London Road, Crawley

Design Developments

Pre-Application Feedback

The information here is the itemised out feedback from the Design Officer on the pre-application submission information. The original comments are in black and our responses are in red.

Pre-App Scheme

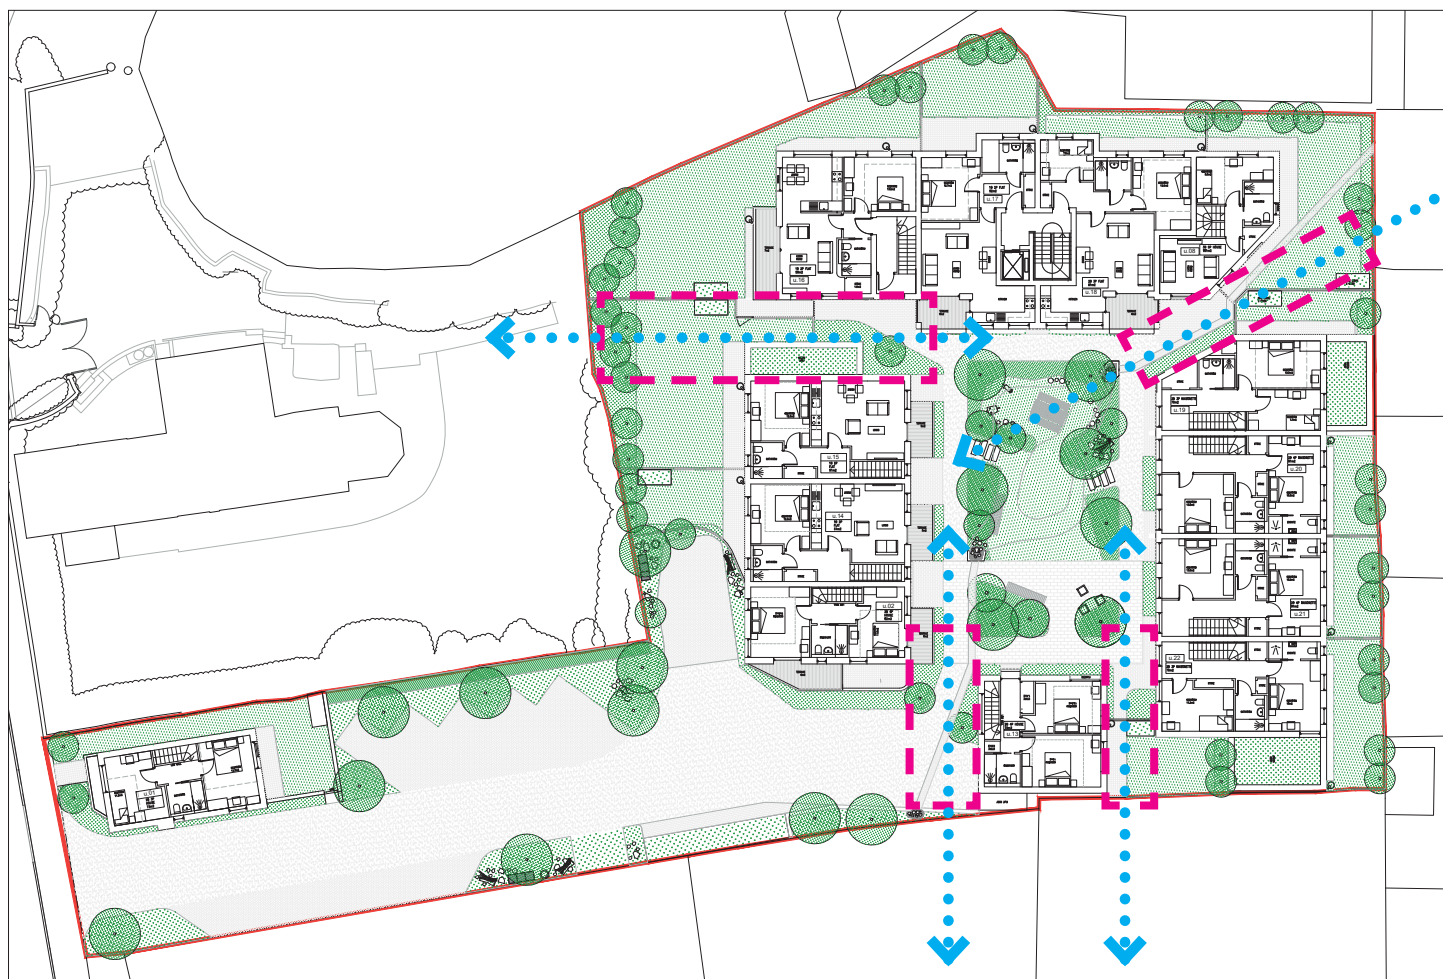
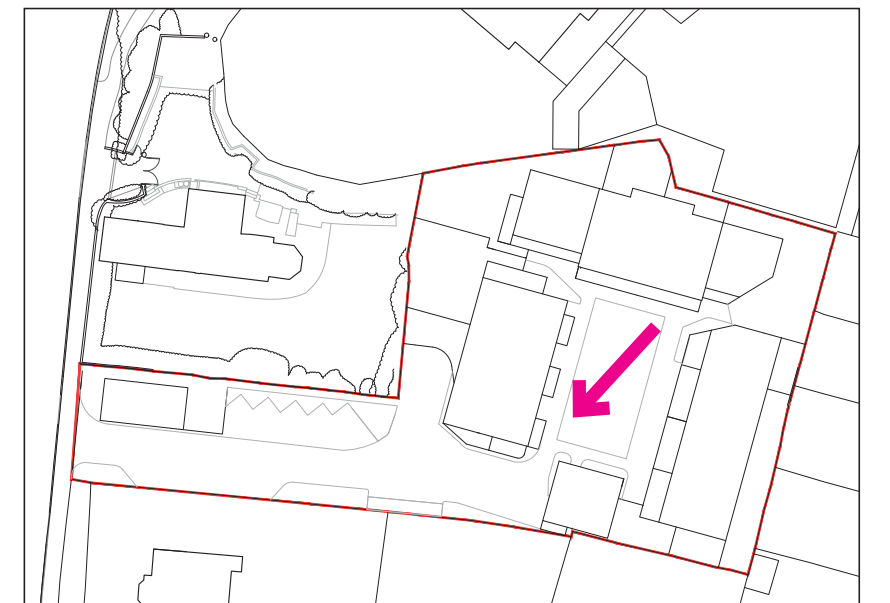
- Cramped in places; reconsider footprints and recoup elsewhere?
- **We have retained the overall principle of the scheme, with a gentle density of housing around a courtyard but have reduced the sizes of the footprints of various blocks. This increases the gaps between the blocks and adds long with across and through the scheme.**

- **The southern block now stands as an individual block and is not connected to the eastern block to creates a long view out of the site.**
- Strong sense of enclosure within the courtyard. Need to introduce a break in the building line somewhere, or set a frontage back to introduce depth.

- **As shown in the revised designs we have reduced the footprints of the various blocks and increased the distances between the blocks to open up the courtyard space and provide far more opportunities for long views out of the courtyard space.**

Revised scheme with much greater gaps between the various housing blocks to open up the courtyard space

Pre-App Scheme

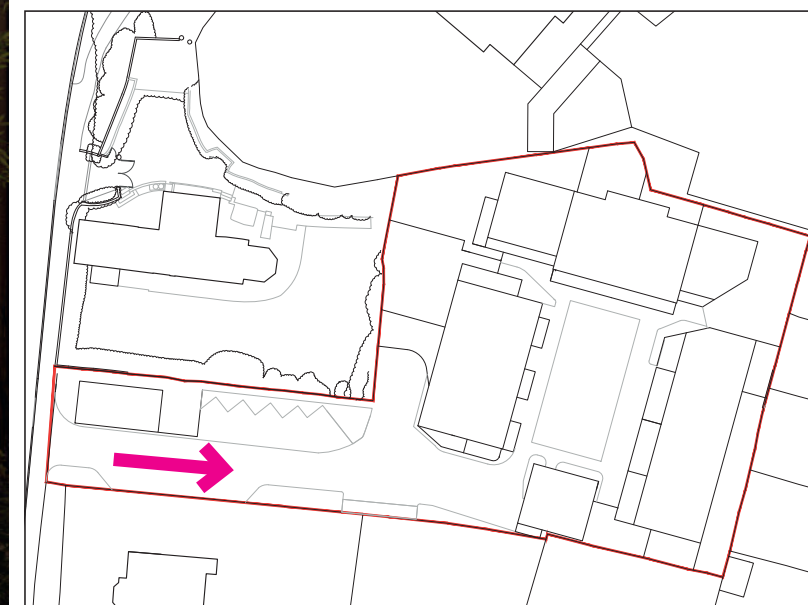
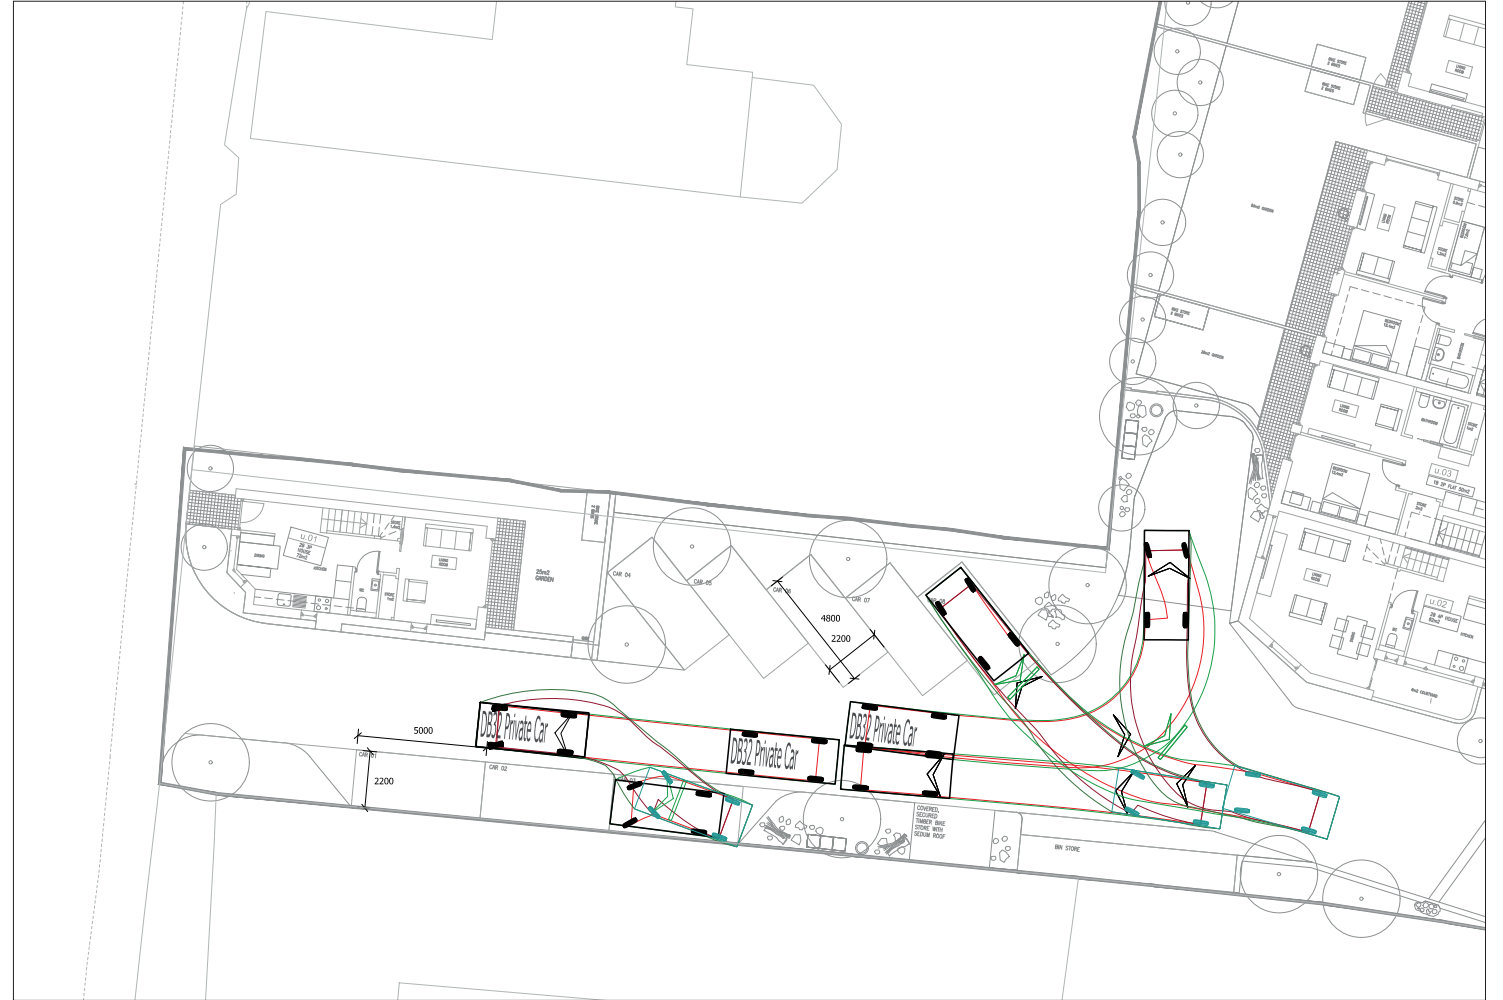
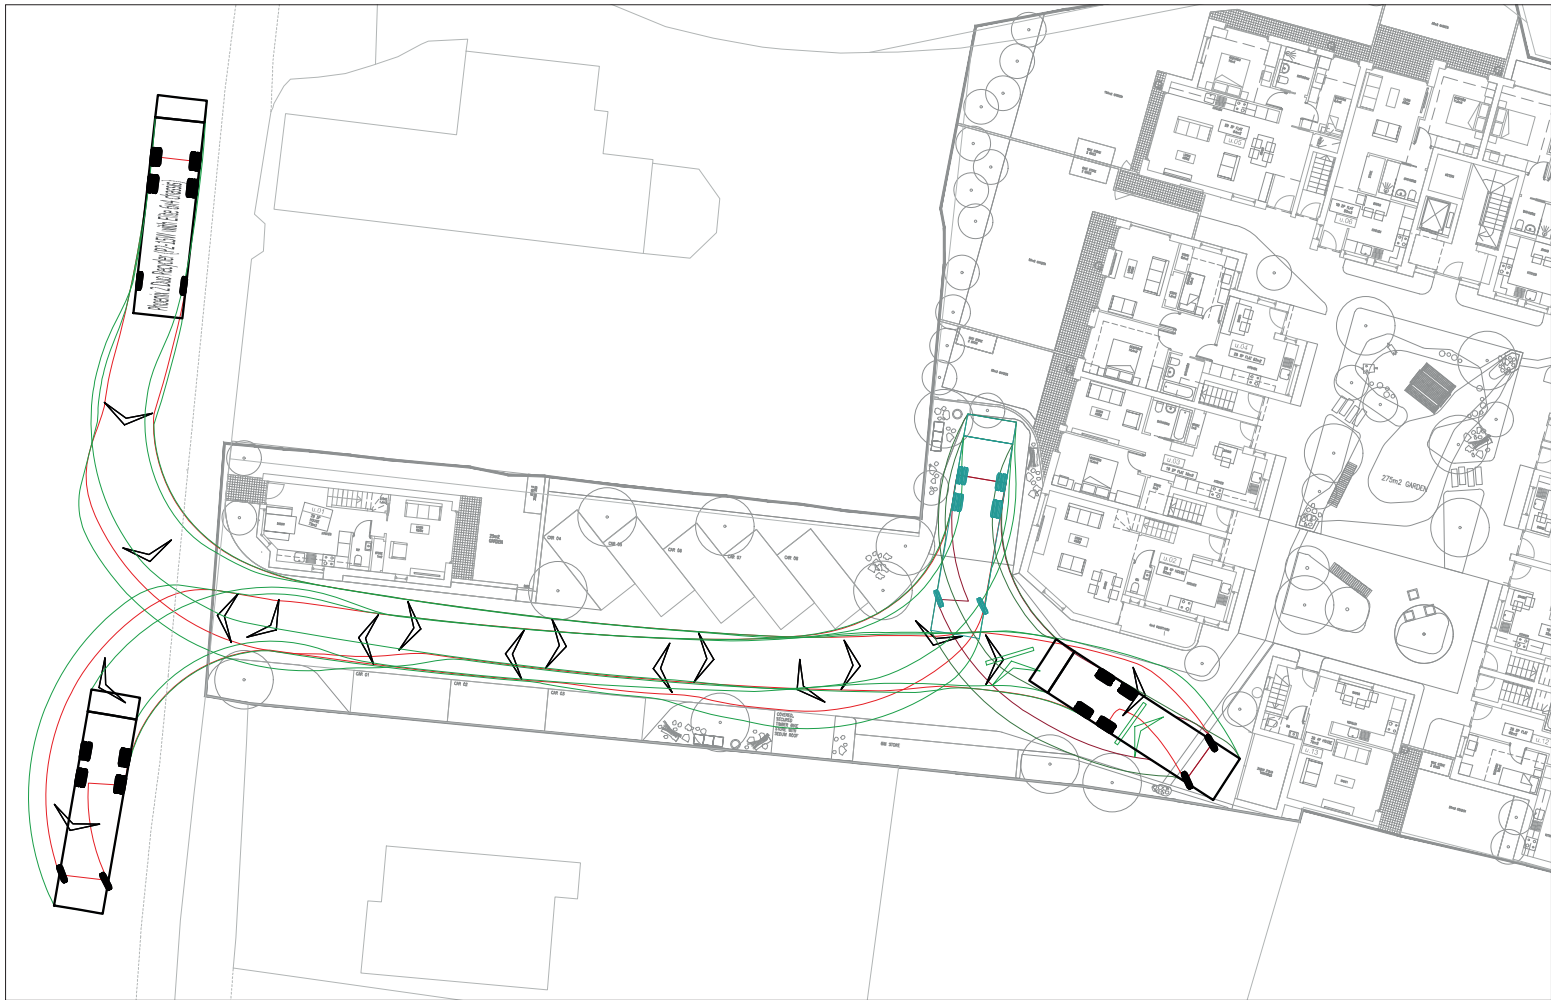
- Layout and design approach to entrance lane clearly predicated on tracking. Relentless hard surfacing presents poor appearance along primary entrance, needs additional landscaping.
- Additional landscaping added along the length of the access road as we have now reduced the width / height of the entrance building.
- Need to be double width along whole length?
- Revised design does not have double width along the whole length. Please see the tracking diagram in the GCO DAS and also the GTA transport report.
- SW corner (around turning head) needs to be improved; hard surfaced, poor appearance
- Design revised to include more landscaping.

- Poor entrance experience; danger of becoming unattractive alleyway.
- Building terminating views into site helps (s/t above) but parking extent along this section is overbearing.
- Overall layout and design sufficient to justify a reduction in parking provision here?
- Need to lose some parking bays to improve layout, as above.
- We have reduced the parking and revised this area to break up the remaining parking and add much more landscape / planting.
- The creates a small-scale domestic space that still meets the various technical requirements such as car and bin truck access.

Revised scheme with the refuse truck access revised to reduce the width of the hardstanding. Parking numbers reduced and significant additional planting and landscaping added

Revised bin truck tracking and car parking tracking to show the revised layout and reduced access requirement

Pre-App Scheme

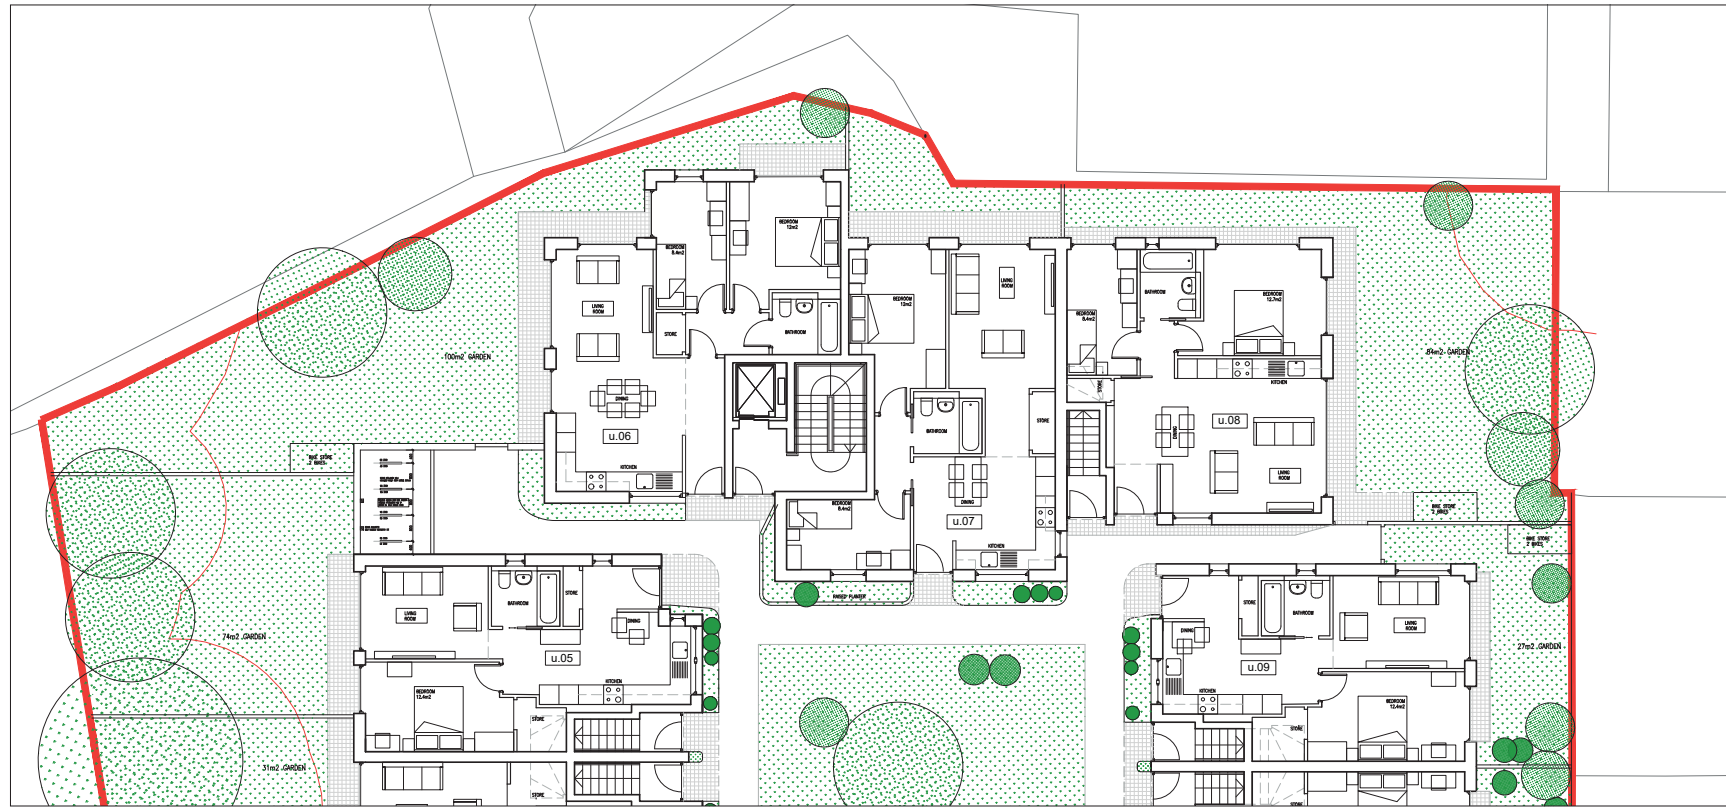
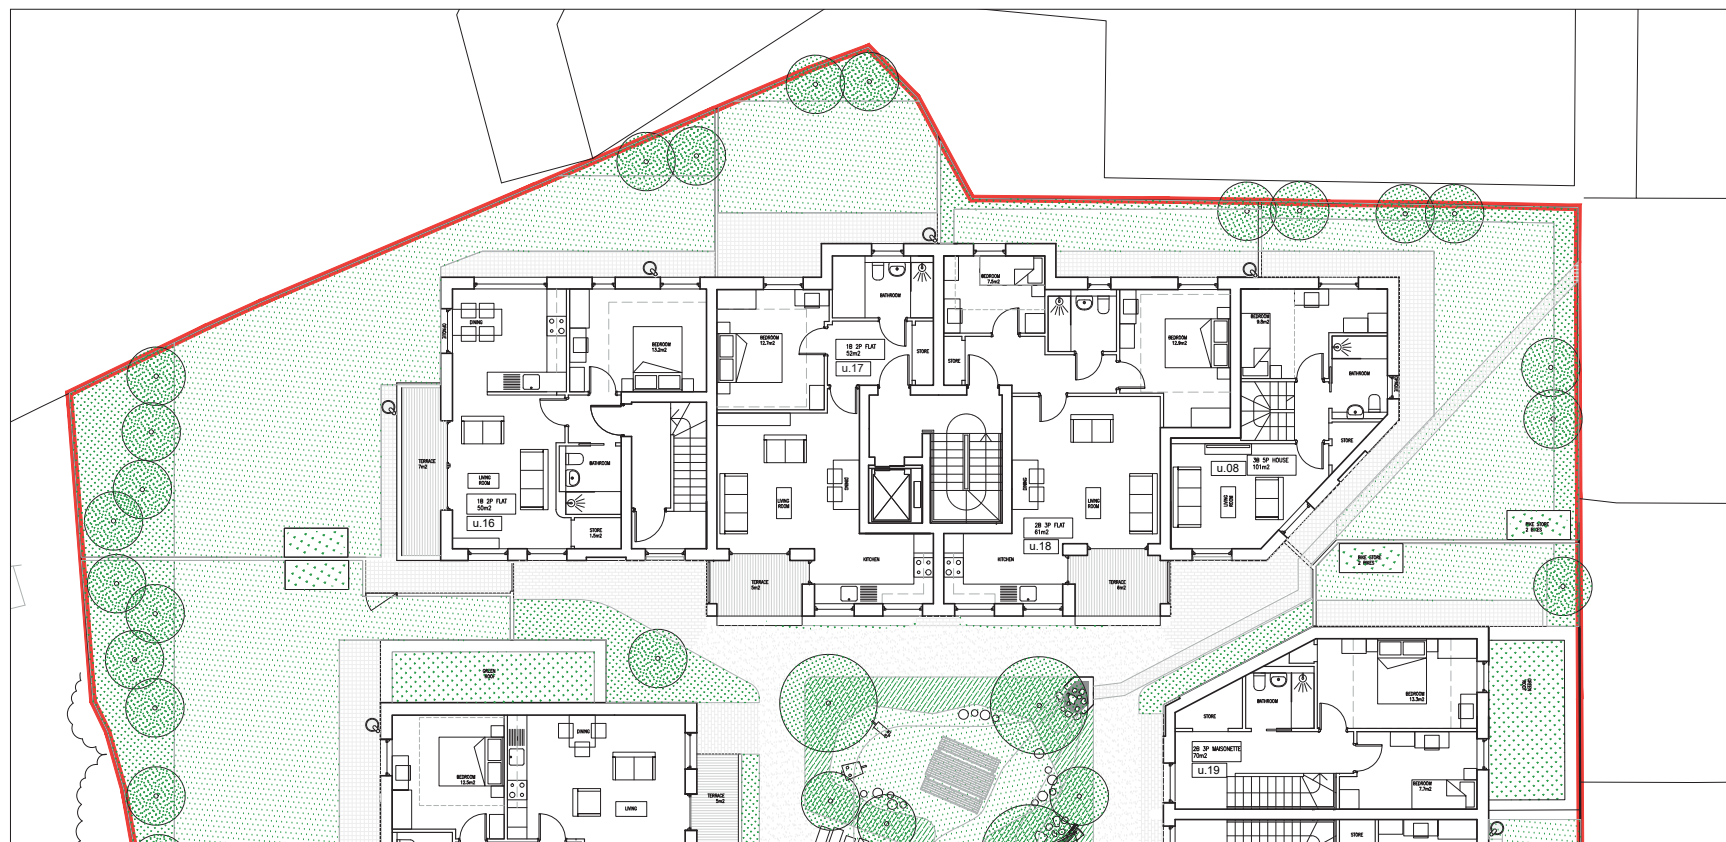
- Northern block – could shift upper massing to W to introduce break in centre of elevation (see illustration of visual gap in tight space/courtyard precedent, image on right of pg. 40 of DAS).
- As per advice we have shifted the northern block. This allows for similar distancing between the northern block and the western / eastern block as shown in our precedent project on page 40 of the DAS.
- Please also see precedent mews project images.
- All our dwellings are dual aspect or in many cases triple aspect.

Revised scheme amended in accordance with the officer's comments to increase the width of the northern block. As per advice this change also allows for far more space to be allowed between the block and allow for long views out of and through the scheme.
